Village of Arlington Heights Building Services Department

To: Sam Hubbard, Development Planner, Planning and Community Development
From: Deb Pierce, Plan Reviewer, Building Services Department
Subject: 120-122 E. Boeger Drive – Preliminary and Final Plat of Subdivision, Preliminary PUD, Rezoning from B-1 and B-2 to the I District, Comp Plan Amendment and Multiple Variations
PC#: 17-004 – Round 1
Date: March 1, 2017
Sam:

Project name: Hearts Place

PLAN COMMISSION PC #17-004
Heart's Place
120-122 E. Boeger Drive
Preliminary Plat of Subdivision, Prelim PUD, Rezone
Round 1

OUTLET CONTROL STRUCTURE

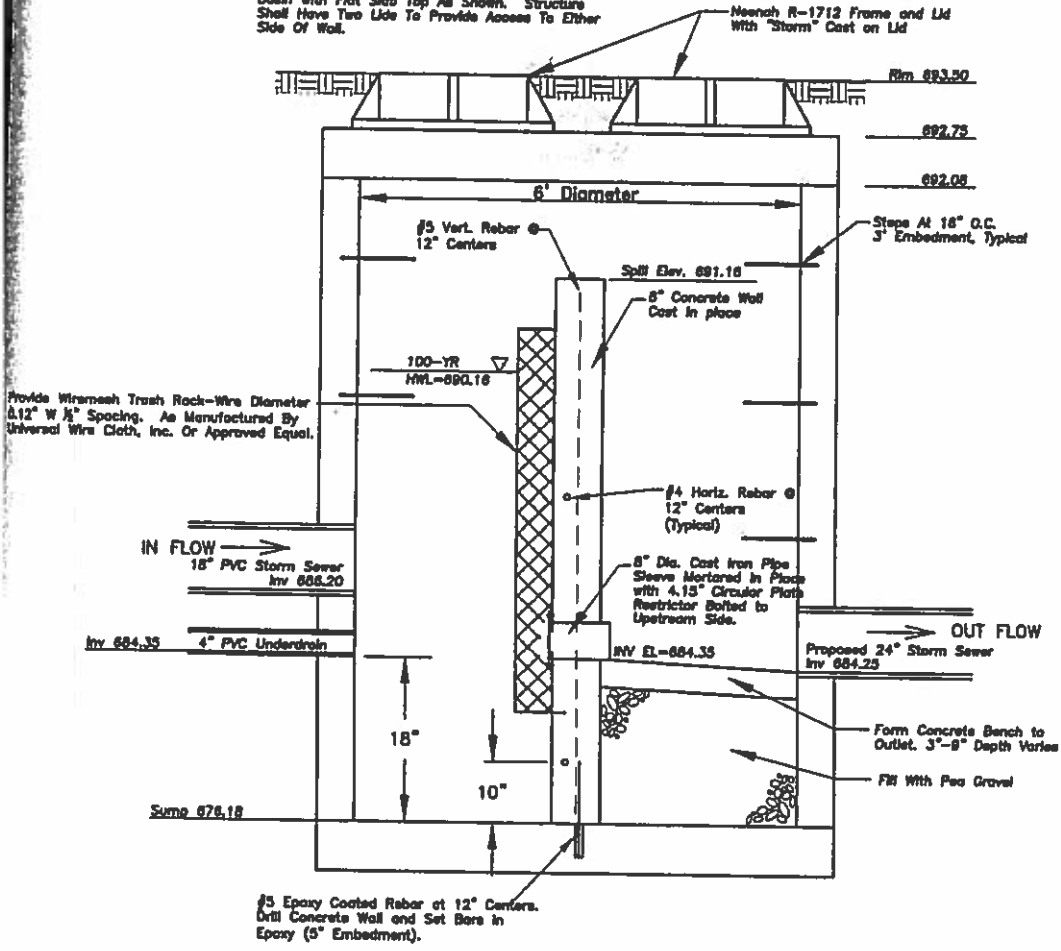
16. Preliminary stormwater detention calculations are acceptable. Eliminate the half-trap and mortared restrictor pipe detail. Revise the proposed restrictor structure to be similar to the attached detail. Clearly show the overland overflow route for the site.

Note:
Structure Shall Be Modified 6" Diameter Catch Basin with Flat Slab Top As Shown. Structure Shall Have Two Lids To Provide Access To Either Side Of Wall.
